Rezoning Transportation Analysis

Petition Number: 2025-094

Date	Description
09-24-25	First Review (TM)

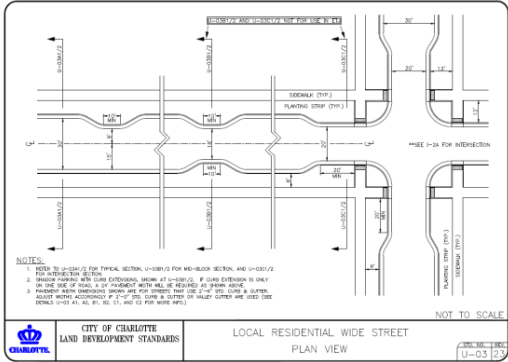
- a. **College View Lane:** Location of future curb and gutter is to be constructed in the final location in accordance with CLDSM U-03.

- a. **Alexander Road:** Location of future curb and gutter is to be constructed in the final location in accordance with CLDSM U-03.

Label and dimension the curb and gutter from the centerline for each road on the site plan.

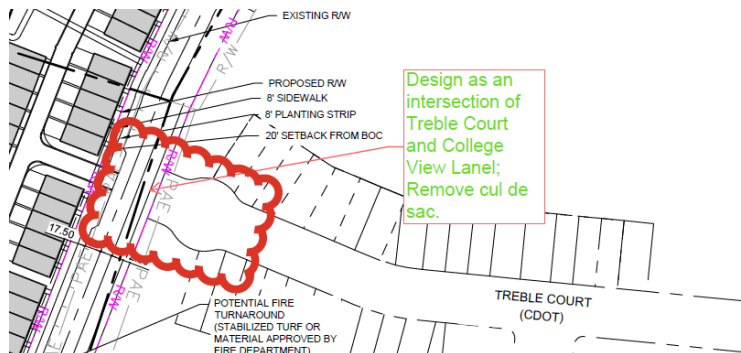
3. Revise site plan and conditional note(s) to commit to dedicate 35.5-feet of right-of-way from the road centerline along all public roadway frontages. The site plan shall label and dimension the right-of-way from the road centerline.
4. Revise Site plan and conditional note(s) to commit to connecting the proposed roadway extension of College View Lane to Silver Birch Lane. Add a conditional note committing to this improvement and revise callout on site plan committing to connecting the roadway.

5. Revise Site plan and conditional note(s) to commit to connecting the proposed roadway extension of College View Lane to existing Treble Court. The cul-de-sac is to be removed, and the intersection is to meet CDOT alignment standards. Add a conditional note committing to this improvement and add a callout on site plan committing to connecting the roadway.

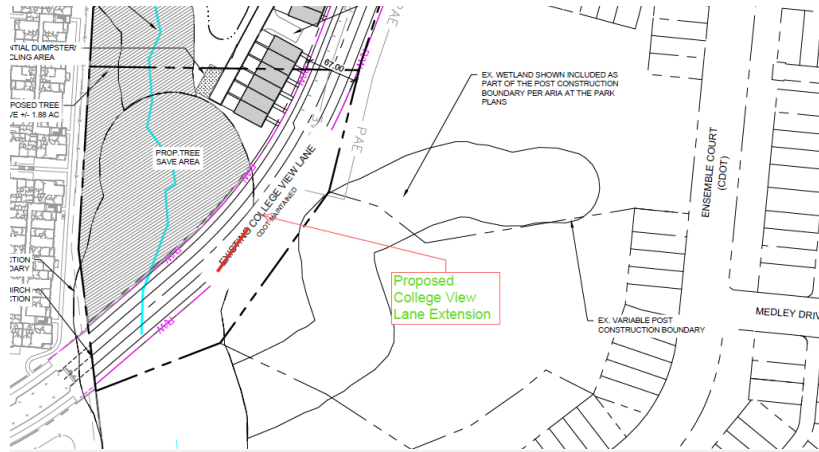
6. Revise site plan and conditional note(s) to commit to constructing an 8-foot planting strip and an 8-foot sidewalk along Ashmore Square Road Extension and Alexander Road. Site plan shall callout and dimension sidewalk and planting strip from the roadway centerline. Add a conditional note committing to this improvement.
7. Revise site plan and conditional note(s) to commit to constructing an 8-foot planting strip and an 8-foot sidewalk on both sides of the proposed Silver Birch Road extension. Revise roadway identifier on site plan to callout roadway as proposed, as this roadway extension does not exist. Add a conditional note committing to this improvement.

8. Revise site plan and conditional note(s) to commit to constructing 1 ADA stalls along the Silver Birch Roadway frontage. Site plan shall show ADA stall placement.
9. **CDOT REQUEST 09-24-25:** CDOT request that a sidewalk is installed on Alexander Road within the existing ROW from the proposed sidewalk along the Alexander roadway frontage to Mallard Creek Road. Sidewalk is to connect with the Mallard Creek Road SUP Capital Improvement project. This pedestrian connection provides meaningful pedestrian accommodations from the proposed development to accessible pedestrian routes on Mallard Creek Road.
